European Union Aviation Safety Agency

Comment-Response Document 2018-08

RELATED NPA: 2018-08 - RMT.0499 - 17.8.2020

ISSUE – 2.(a)

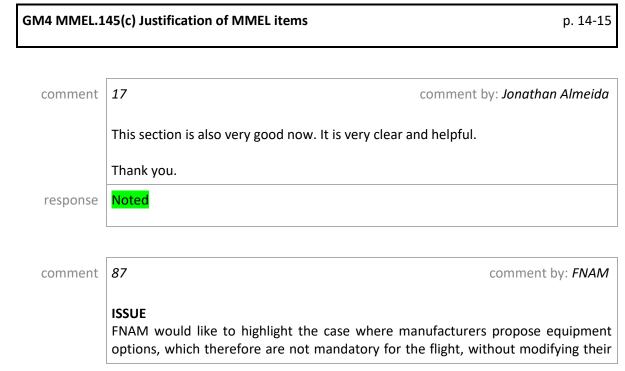
« In such cases, coordination between the aircraft and the engine manufacturers is necessary to complete the demonstration of compliance for the MMEL. » FNAM wonders what would be the measures for MMEL already written. Should all constructors update their MMEL? It would therefore impact all operators Plus, FNAM wonders what would be the measures for legacy aircraft or constructors not able to modify their MMEL according to such requirements. PROPOSAL Add measure for legacy aircraft and constructors not able to update their MMEL: and

Add measure for legacy aircraft and constructors not able to update their MMEL; and Explain transition measures for manufacturers (engine or aircraft) but also for operators and maintenance organizations

response Not accepted.

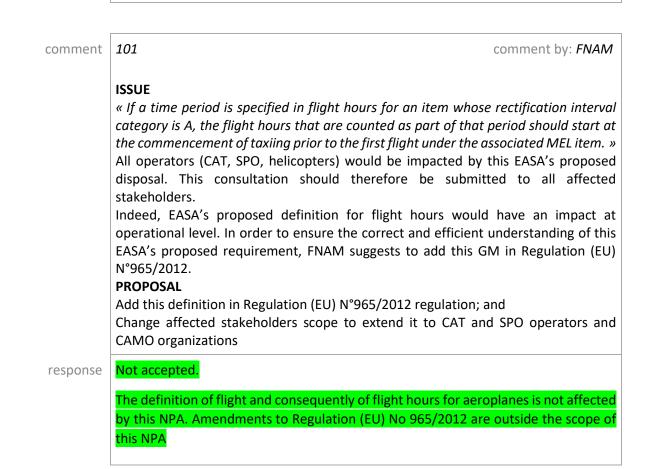
AMC M.A.306(a) – Aircraft Technical Log System: Section 3 should contain details of all information considered necessary to ensure continued flight safety. Such information includes: (i) the aircraft type and registration mark, (ii) the date and place of take-off and landing, (iii) the times at which the aircraft took off and landed, And; FAA CFR, Title 14, Part 1, par. 1.1: Time in Service. With respect to maintenance time records, means the time from the moment an aircraft leaves the surface of the earth until it touches it at the next point of landing. The time between take-off and landing is commonly referred to as 'Flight Hours', another (second) definition would introduce quite a lot of misunderstanding. Propose to change this text, if taxi time is to be accounted for, as follows; If a time period is specified in flight block hours for an item whose rectification interval category is A, the flight hours that are counted as part of that period should start at the commencement of taxiing under its own power with the intention of take-off (off-blocks) prior to the first flight under the associated MEL item, until the termination of the complete flight cycle (on-blocks). Not accepted

The definition of flight and consequently of flight hours for aeroplanes is not affected by this NPA. The proposed text is already part of the above definition.

ISSUE – item 7

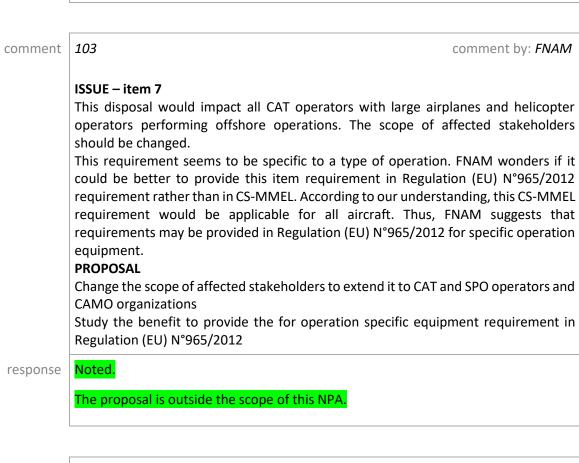
This disposal would impact all CAT operators performing transport over oceanic areas. The scope of affected stakeholders should be changed.
